TOWN OF COTTESLOE

# ROAD SAFETY REVIEW

## EXISTING ROAD

**Location** - Curtin Ave / Princes St  
**Suburb** - Cottesloe  
**LGA** - Town of Cottesloe  
**Date** - 8 July 2011

Intersection Curtin Avenue/Princes Street, Cottesloe

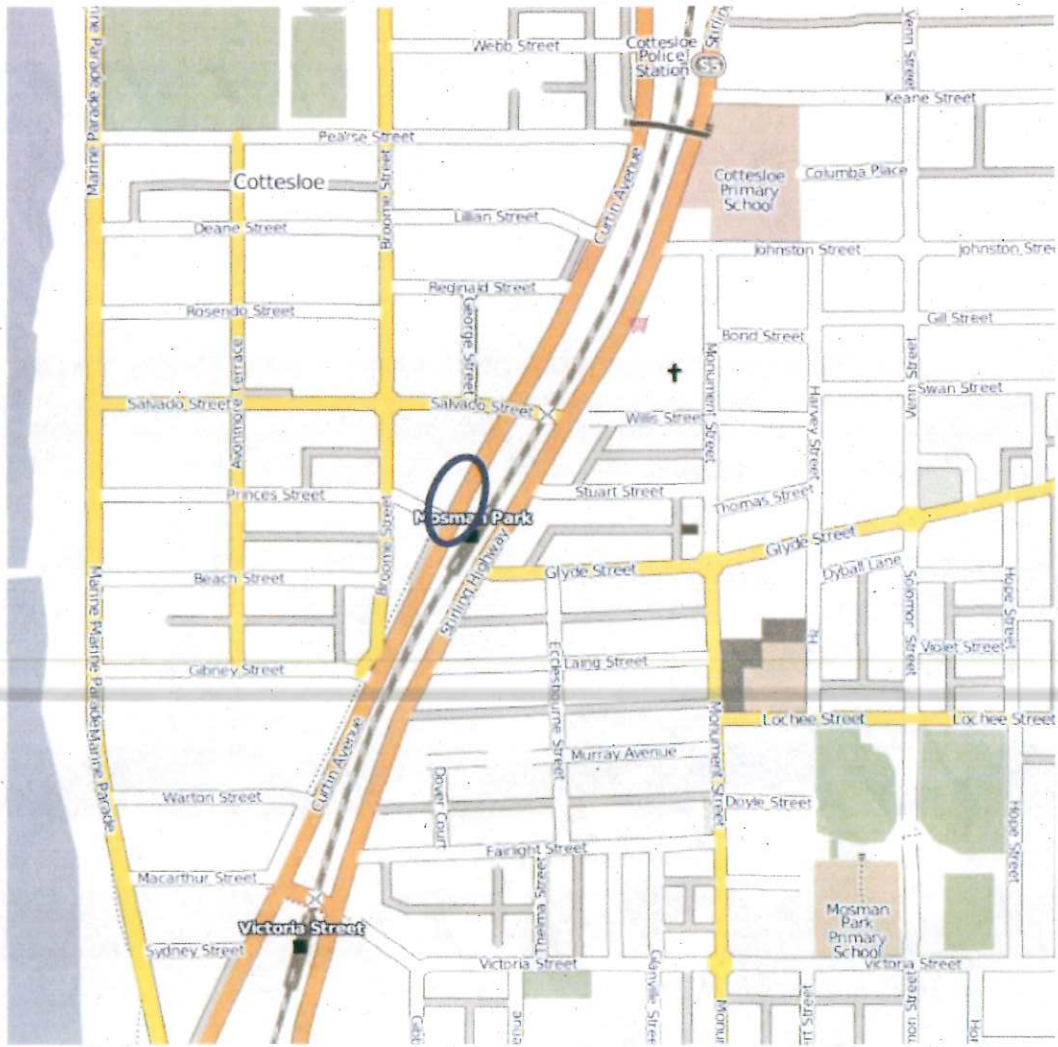
- ① 2 ped refuges
- ② provide additional light
- ③ upgrade path
